From: [Tania Azara](#)
To: [David Flynn](#); [Martin Doyle](#); [Ewa Babiarczyk](#)
Cc: [historiclandfill.applications](#); [REDACTED]
Subject: Concerns Regarding Impact of Whitegate Landfill on High Arsenic Levels in Drinking Water Well
Date: Thursday 21 November 2024 09:01:22
Attachments: [Summary Points and Conclusion.pdf](#)
[Position Paper Whitegate landfill.pdf](#)

Position Paper Regarding the Environmental Risk Assessment of Whitegate Historic Landfill

Prepared by: Paula Treacy, Ph.D. Env. Sc., B.E. Civ.Eng.

Figure 1 Groundwater Well Locations

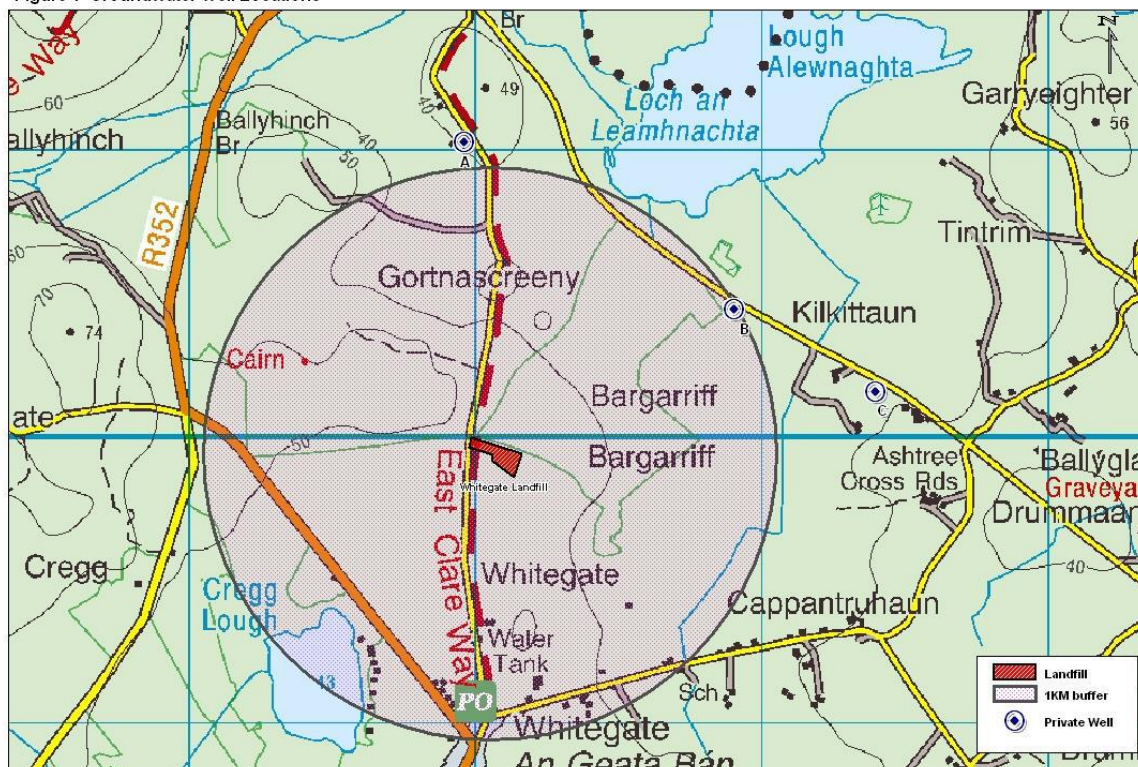
unlined solid waste landfills, on arsenic mobilisation in shallow groundwater systems. This is discussed in detail below in Section 3.0. The exploratory site investigation reported **there was a direct discharge of contaminated leachate to groundwater at the site and that groundwater movement** (and associated leachate movement) appeared to be from a **south-west to north-east direction**, based on **observation of seeps** in each trial hole. Well B is located 0.9 km along this gradient, due north-east of the landfill (see Figure 1).

- There are anomalies in this report with respect to the location and description of Well B (identified in Report 1 as Tania and Noels’ well) which is located 0.9 Km due north-east of the Landfill (see Figure 1 from the 2009 Tier 2 report). The Tier 3 report refers to Well B as:

Fig. 3.2, from the Tier 3 report does not show the correct location of Well B (Tania and Noels’ well) as shown in Figure 1. It also does not indicate what well is 1.5 km away from the landfill.
